PROJECT PLANS FOR CONSTRUCTION ON
STATE HIGHWAY
IN SACRAMENTO COUNTY
FROM AMERICAN RIVER BRIDGE
TO 0.3 MILE NORTH OF
ARDEN WAY UNDERCROSSING

2 REPLACED PER ADDENDUM No. 2 SEPTEMBER 15, 2016

CONTRACT No. 03-OH11U4
PROJECT ID 0316000035

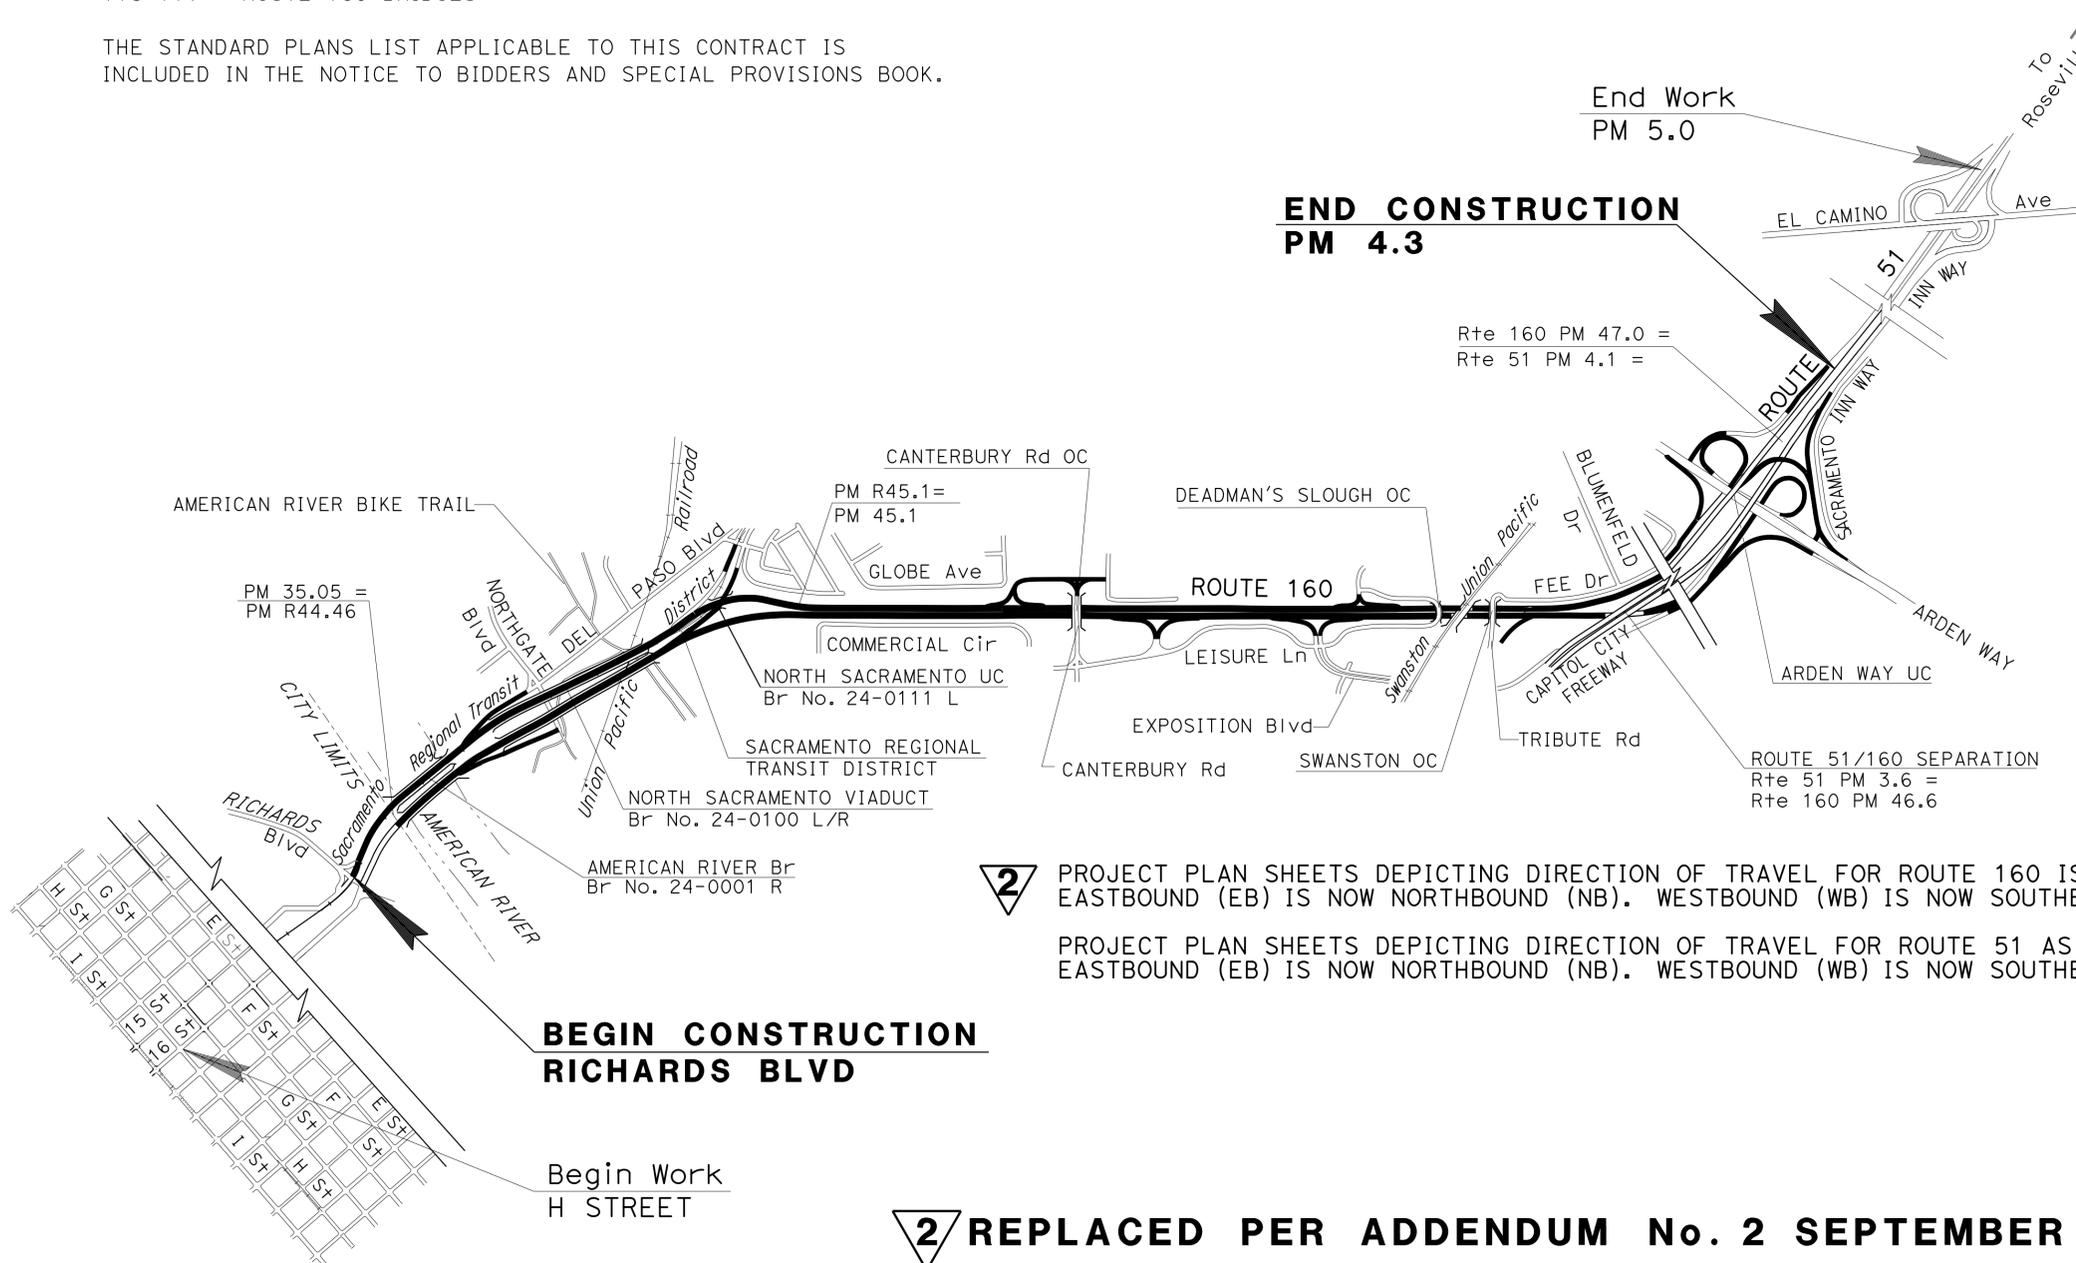
2 PROJECT PLAN SHEETS DEPICTING DIRECTION OF TRAVEL FOR ROUTE 160 IS CHANGED: EASTBOUND (EB) IS NOW NORTHBOUND (NB). WESTBOUND (WB) IS NOW SOUTHBOUND (SB).
PROJECT PLAN SHEETS DEPICTING DIRECTION OF TRAVEL FOR ROUTE 51 AS EASTBOUND (EB) AND WESTBOUND (WB) IS CHANGED: EASTBOUND (EB) IS NOW NORTHBOUND (NB). WESTBOUND (WB) IS NOW SOUTHBOUND (SB).
